Product / Process Change Notification (PCN)

PCN #: PCN_FeSTAR-RING_20230801

Affected Series: STAR-RING; 742715x

New carton box	Old carton box

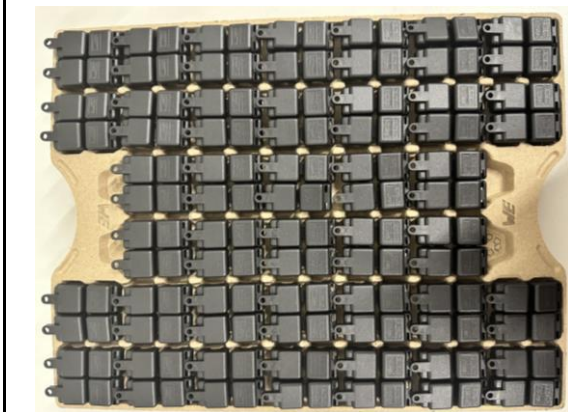
The tray changes in the design and in the size from a double wall corrugated cardboard tray to a paper mould tray. The outer carton size and packaging quantity will change as detailed in the table below. The carton box material will remain double wall corrugated cardboard but changes to a better quality for improved transportation safety.
